REMARKS/ARGUMENTS

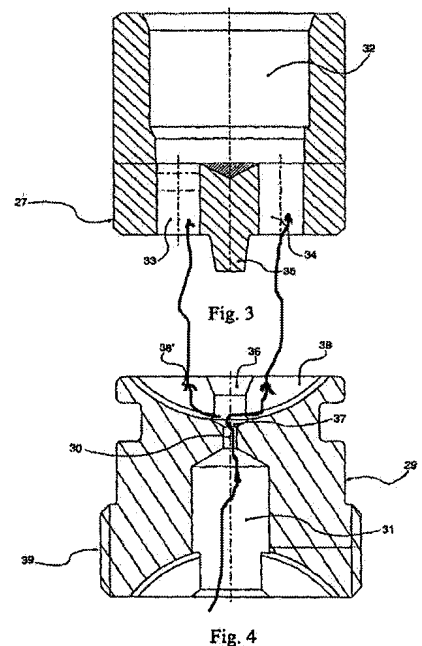
The drawings were additionally objected to as not including reference sign 34’ as mentioned in the specification, and for including reference numeral 33 not mentioned in the specification. Applicants have amended the specification to replace typo 34’ with numeral 33.

The drawings were furthermore objected to because it was unclear to the Examiner how the conduit and the routes 38, 38’ communicate. First, Applicants assert the drawings, although not formal production engineering drawings, are more than sufficient to communicate to those of ordinary skill in the art how to make and use the claimed subject matter. Second, (as shown in the marked up Figs. 3-4 to the right) when the protrusion 35 of the sleeve 27 is inserted in the conduit 36 of the part 29 (with or without a ball valve member), fluid may flow through the inlet 30, between the seat 37 and its corresponding valve member, into the clearance spaces or routes 38, 38’, and into the channels 33, 34 of the sleeve 27. Third, Applicants have not claimed this specific relationship and any suitable valve and valve seat arrangement may be used.
